2020/5647/P
7 A, B, C Bayham Street

Delegated Report (Members Briefing)		Analysis sheet		Expiry Date:		28/01/2021	
		N/A		Consultation Expiry Date:		31/01/2021	
Officer				Application Number(s)			
Patrick Marfleet				2020/5647/P			
Application Address				Drawing Numbers			
7 A, B, C Bayham Street London NW1 0EY				Please refer to draft decision notice			
PO 3/4	Area Team Signature	C&UD	Authorised Officer Signature				
Proposal(s)							
Variation of conditions 2 (approved plans), 5 (waste storage), 9 (SUDs), 14 (green roofs and living walls), 24 (bird and bat boxes) and removal of conditions 11 (CHP), 12 (CHP stack) and 16 (greywater recycling) of planning permission 2018/3647/P dated 28/08/2020 (Demolition of existing office buildings (B1) and erection of 5 storey (plus two storey basement) building comprising mixed office (B1) and hotel (C1) use).							
Recommendation(s):		Grant variation of condition subject to s106 legal agreement

DECISION
Variation of conditions 2 (approved plans), 5 (waste storage), 9 (SUDs), 14 (green roofs and living walls), 24 (bird and bat boxes) and removal of conditions 11 (CHP), 12 (CHP stack) and 16 (greywater recycling) of planning permission 2018

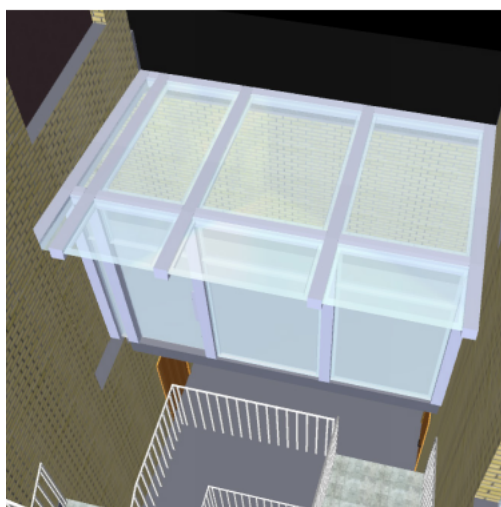
2.3.3 Whilst the current proposals do seek to increase the height and width of the approved roof plant enclosure (as a result of ASHPs being incorporated into the scheme), it would still remain largely unseen in long and short views from the public realm along Bayham Street and is not considered to cause harm to the character and appearance of the conservation area as a result. The plant enclosure would be more visible in views from King's Terrace to the rear however, it would be commensurate with the size and scale of the buildings in this part of the conservation area (see images below) and is thus considered acceptable in terms of its visual impact

3D view of canopy from stairwell

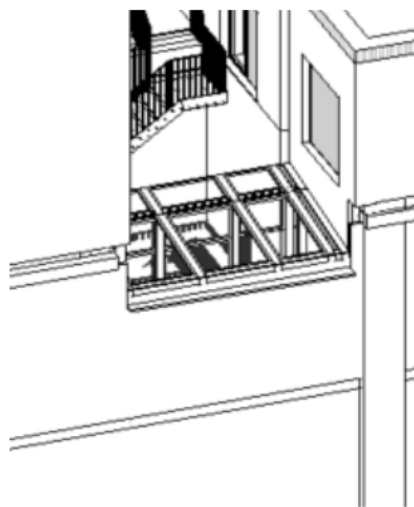
2.4.3 Officers also note the concerns raised from neighbouring residents with regard to the noise that could be generated from office users entering the building via the proposed access route to the north of the site. However, the applicant has submitted amended plans to demonstrate that this access route/walkway would be fully enclosed by a glass roof (see image below), similar to the glazed atrium roof of the previous approval.

3. *The proposed arched office entrance initially proposed has been removed from the plans.*
4. *The applicant has submitted amended plans to show the proposed walkway/undercroft to the north would be fully enclosed by a glass canopy.*
